DUKE POWER COMPANY

OCONEE NUCLEAR STATION

TECHNICAL SPECIFICATIONS

1.0	DESCRIPTION OF PROPOSED CHANGES	1
2.0	BACKGROUND	1
3.0	TECHNICAL JUSTIFICATION	2
3.1	CHANGES TO TECHNICAL SPECIFICATION 5.5.2	2
3.2	CHANGES TO TECHNICAL SPECIFICATION 5.5.7	5
3.3	CHANGES TO SLC 16.6.2, CONTAINMENT TENDON SURVEILLANCE PROGRAM	6
4.0	REFERENCES	7
5.0	ENCLOSURES	8
1.	REVISED SLC 16.6.2 PAGES	8
2.	CURRENT SLC 16.6.2 WITH MARKED PAGES	8

Figure 16.6.2-1
Dome Tendon PLLs and MRVs

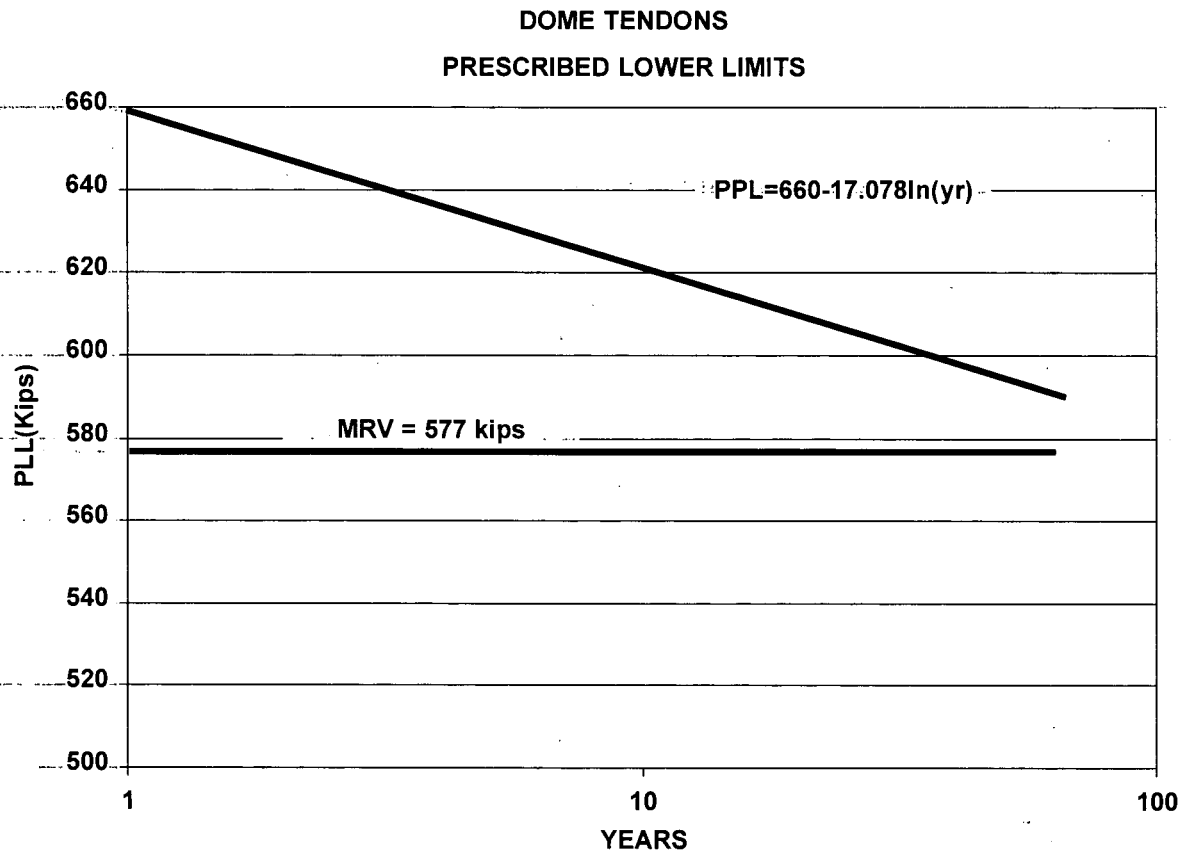
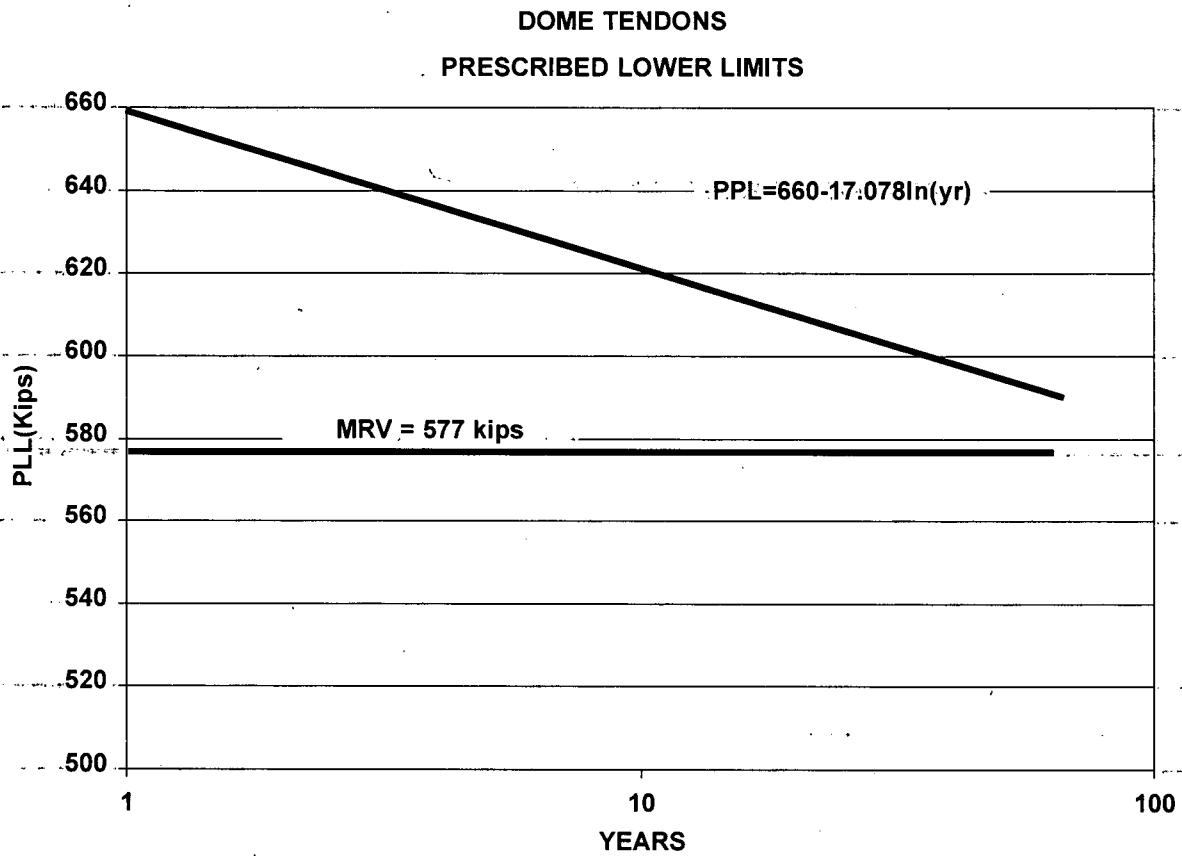
On approval of the above change to TS 5.5.7, Duke will revise SLC 16.6.2 as indicated in Enclosures A and B to this Attachment. These changes will reference the ASME XI Containment ISI Program and remove these details from the SLC for inservice inspection of the concrete containment post-tensioning system. Figures 16.6.2-1, 16.6.2-2, and 16.6.2-3 (PLLs and MRVs for the Dome, Hoop, and Vertical Tendons respectively) will continue to be maintained in this SLC.
